MSF_ DAS

5.0 Involvement and Evaluation

Involvement and Evaluation | Layout Adjustments

5.1 Layout Adjustments

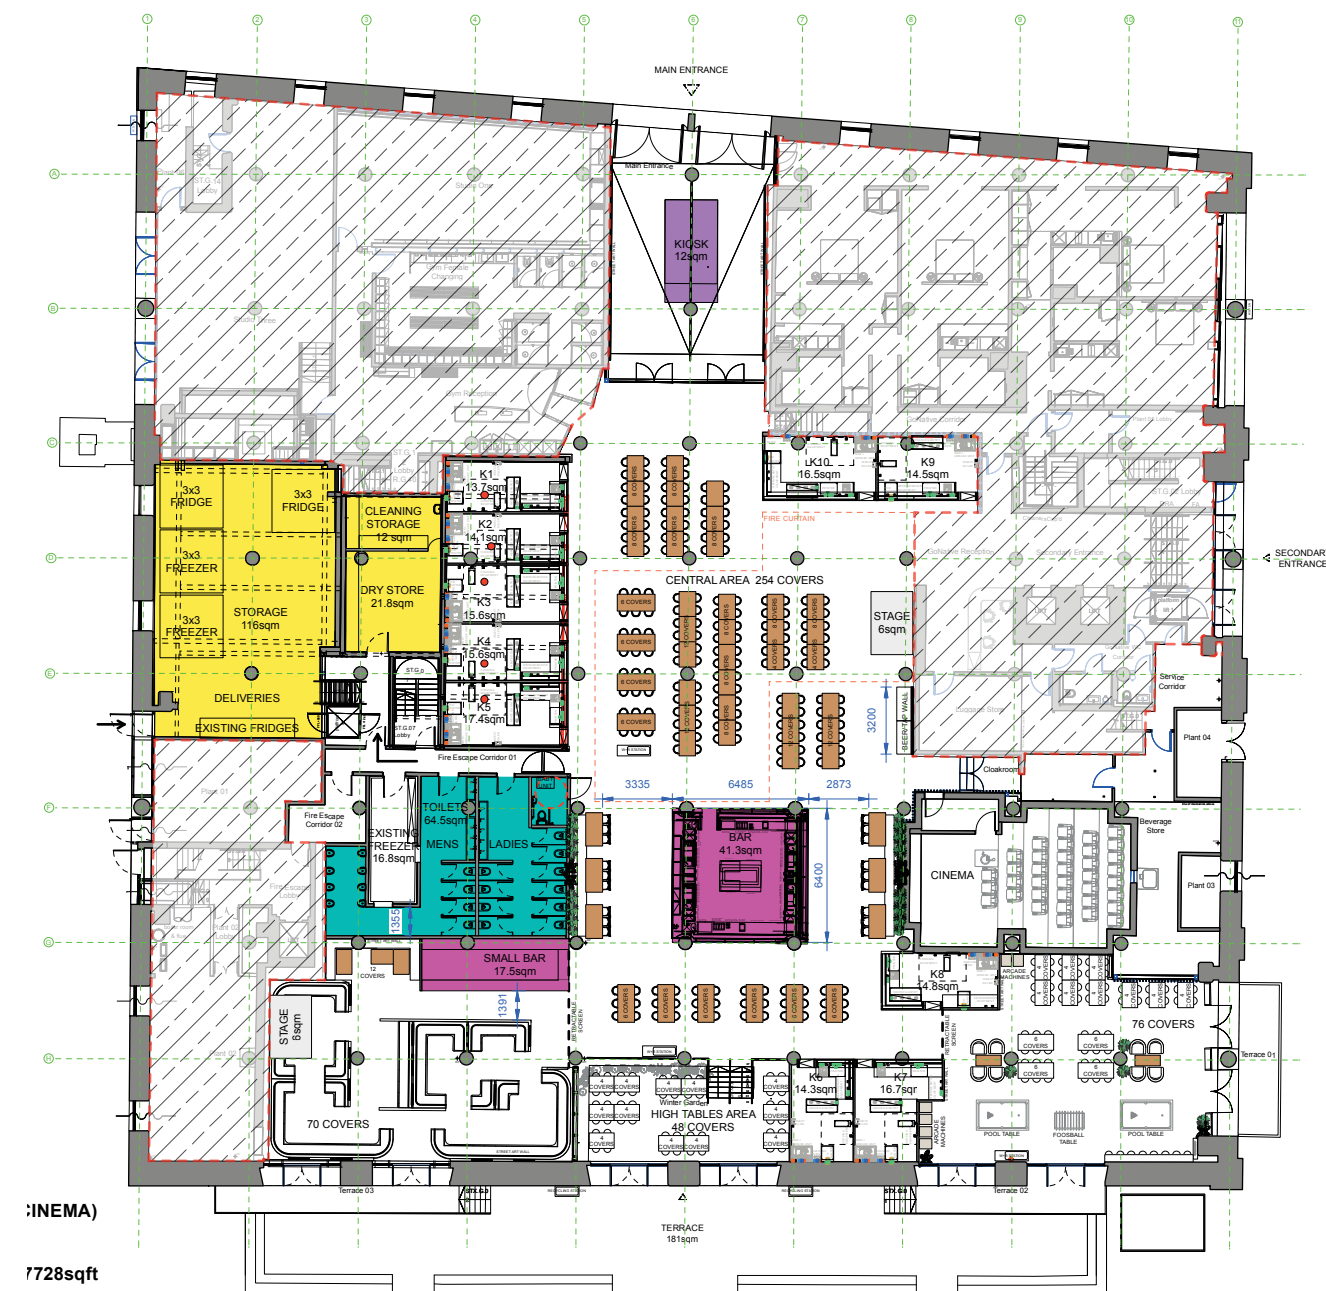
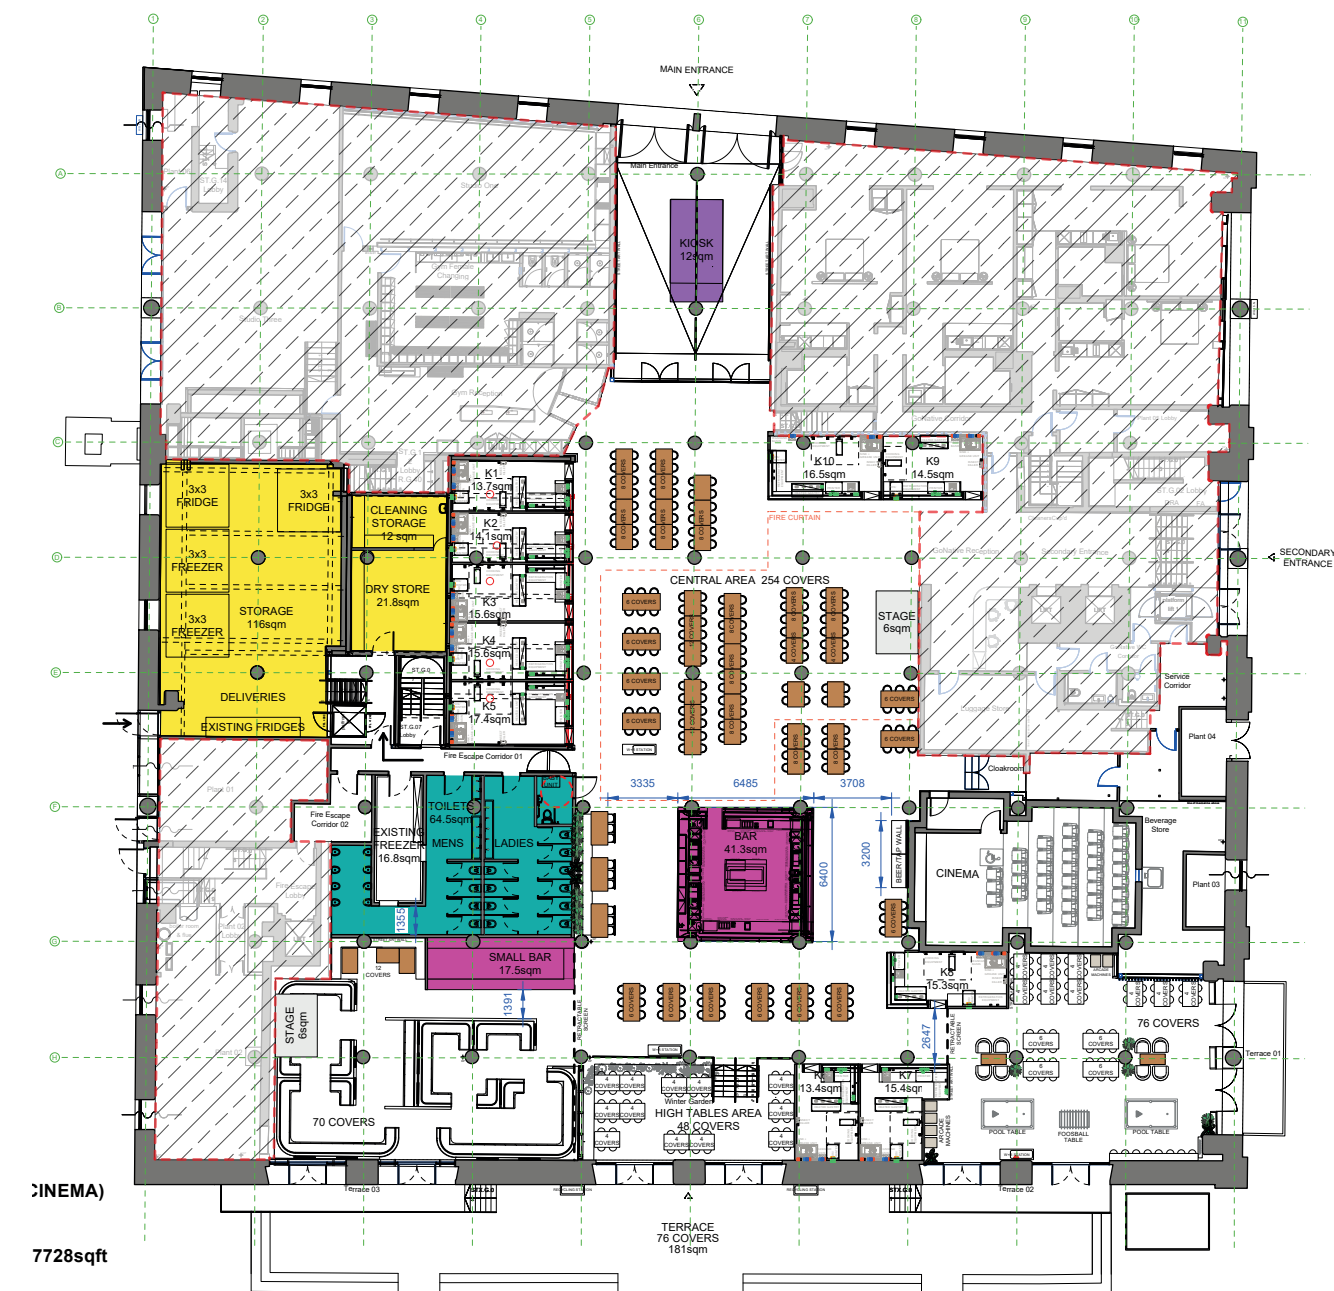
- * K6 and K7 Repositioning: Both units were moved behind the existing columns following feedback from the Heritage team.
- * Games Area Revision: The layout was updated to improve the visibility of the column adjacent to K8, enhancing both aesthetics and spatial orientation.

5.2 Column Visibility

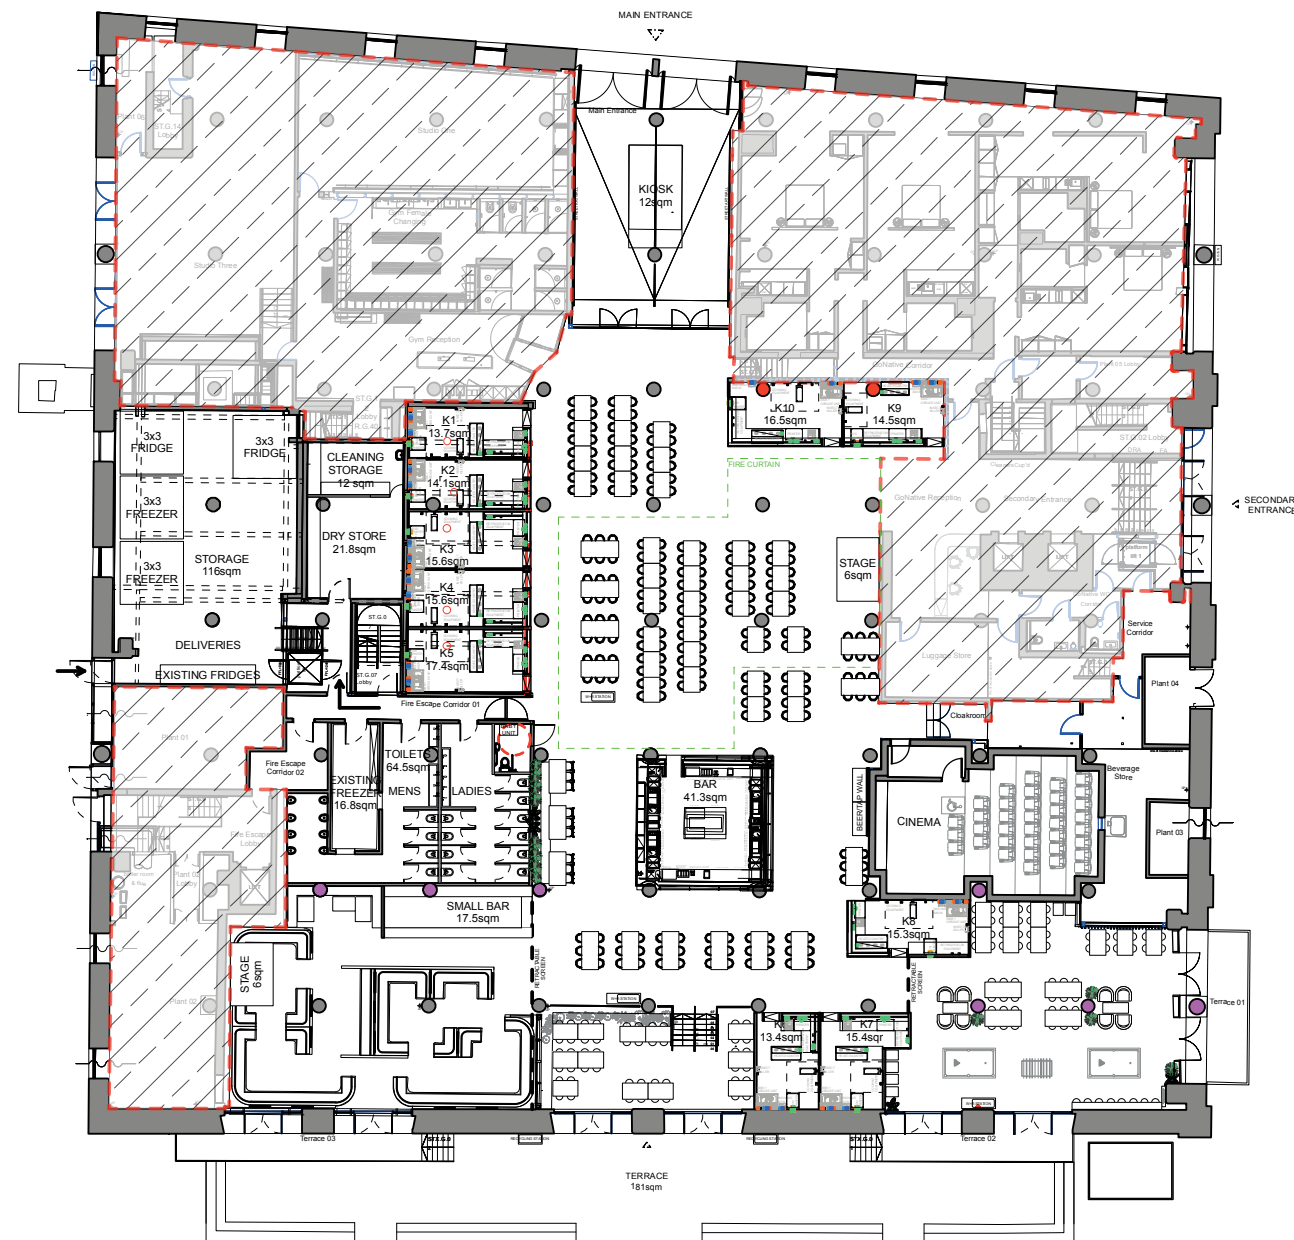
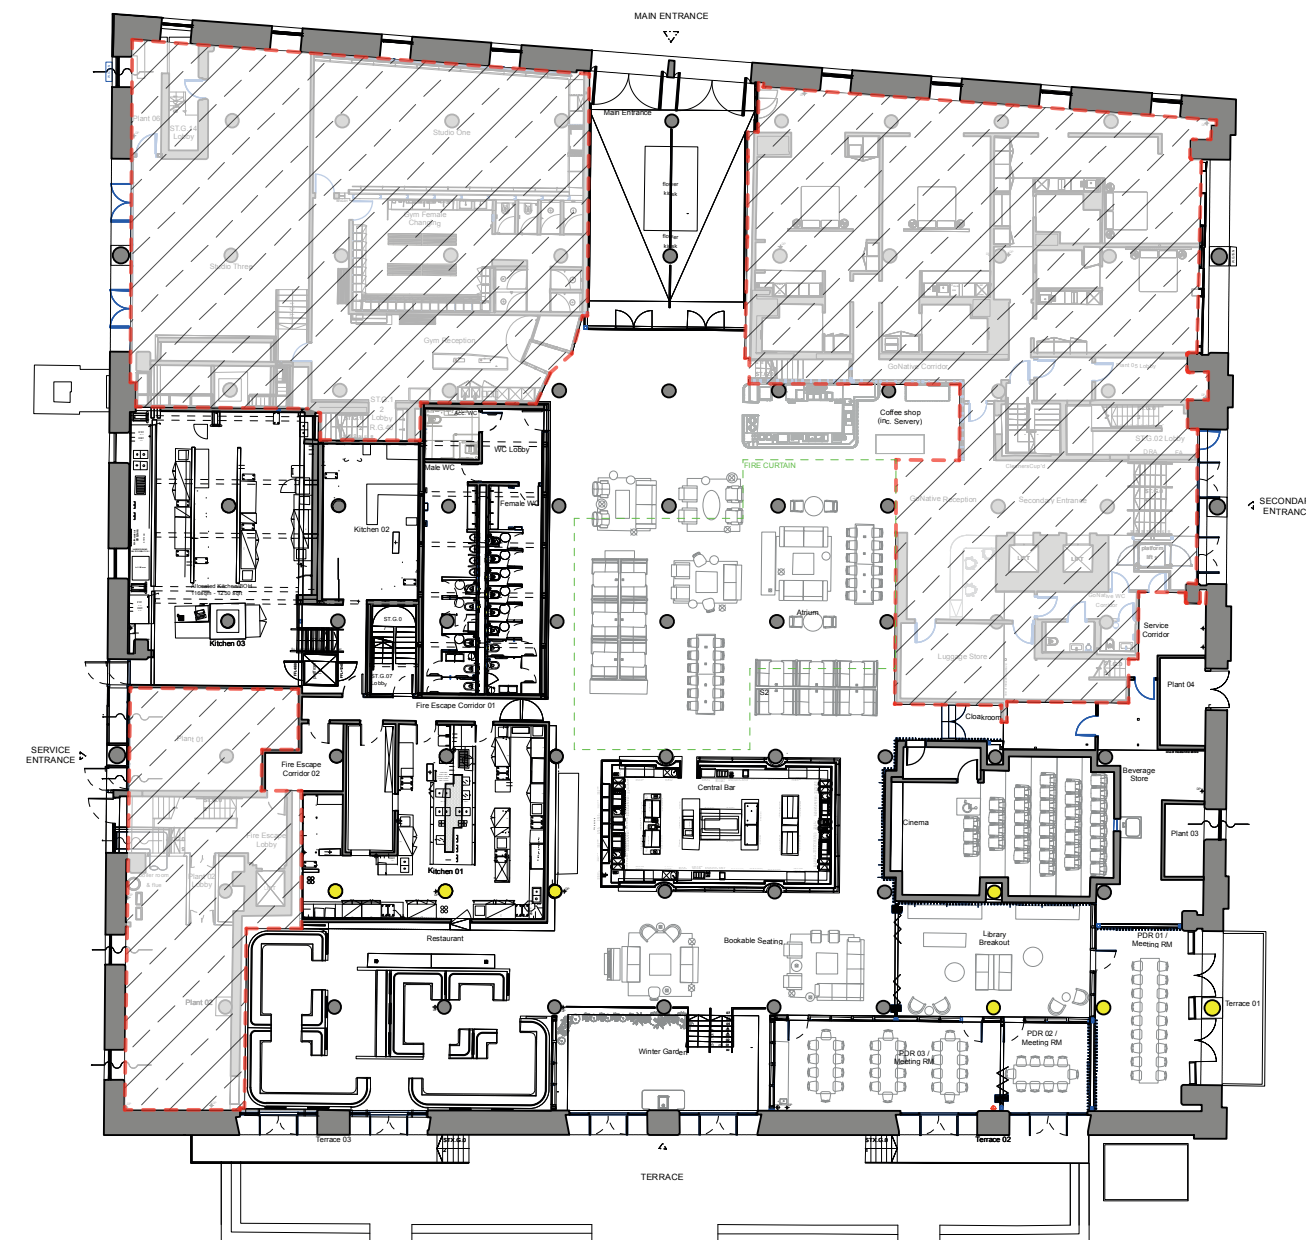
- THE PROPOSED LAYOUT IMPROVES DE VISIBILITY OF 7 EXISTING COLUMNS
- THE PROPOSAL LAYOUT REDUCES THE VISIBILITY OF 2 EXISTING COLUMN

- 7no. EXISTING COLUMNS WITH LESS VISIBILITY THAT THE PROPOSAL

Adjustments to the overall layout have improved the visibility of seven existing columns, ensuring they contribute to the character and spatial definition of the venue
